Access Compliance Report

Public Rights-of-Way

(Curb Ramps)

Intersection ID: 18366	Main Street: BRIARDALE_DR	Cross Street: SHARON_FOREST_DR	Location: SW
ADA ID: 64B542B11ECB	Ramp Type: PerpDiag	Initial Pass/Fail: Fail	Overall Compliance: No
Severity Score: 12.5			
Codes/Mitigation Info/Possible Solution		Field Measurements/Component Compliance

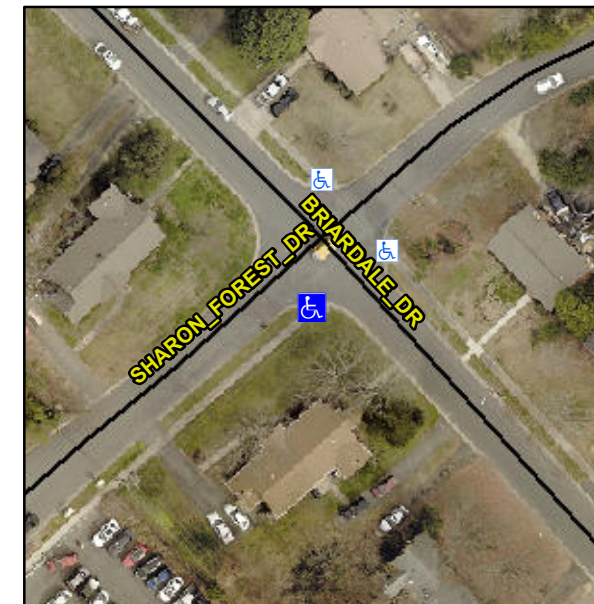
Not Found, R304.5.3

Compliance	Description	Data	Compliance	Description	Data
N/A	Ramp Length (in)	79.0	Yes	Ramp Slope (%)	7.9
Yes	Ramp Width (in)	48.0	No	Ramp XSlope (%)	5.8
N/A	Flare Type LT	N/A	N/A	Flare Type RT	N/A
N/A	Flare Slope LT (%)	N/A	N/A	Flare Slope RT (%)	N/A
N/A	Flare Traversable LT?	N/A	N/A	Flare Traversable RT?	N/A
N/A	Landing Length (in)	N/A	N/A	DWS Provided?	N/A
N/A	Landing Width (in)	N/A	N/A	DWS Contrast?	N/A
N/A	Landing Slope (%)	N/A	N/A	DWS Length (in)	N/A
N/A	Landing X Slope (%)	N/A	N/A	DWS Full Width?	N/A
N/A	Landing Curb? (Y/N)	N/A	N/A	DWS Offset (in)	N/A
N/A	Shared Landing?	N/A			
N/A	Gutter Ponding?	N/A	N/A	Gutter Slope (%)	N/A
N/A	Gutter Lip Ht (in)	N/A	N/A	Gutter X Slope (%)	N/A
N/A	Painted X Walk1?	No	N/A	Painted X Walk2?	No
	X Walk 1 Direction	To NE		X Walk 2 Direction	To NW
N/A	X Walk 1 Width (in)	N/A	N/A	X Walk 2 Width (in)	N/A
	X Walk 1 Slope (%)	0.3		X Walk 2 Slope (%)	5.1
	X Walk 1 X Slope (%)	2.5		X Walk 2 X Slope (%)	2.3

Remove & Replace Curb Ramp With Two New Directional Ramps or Equivalent.
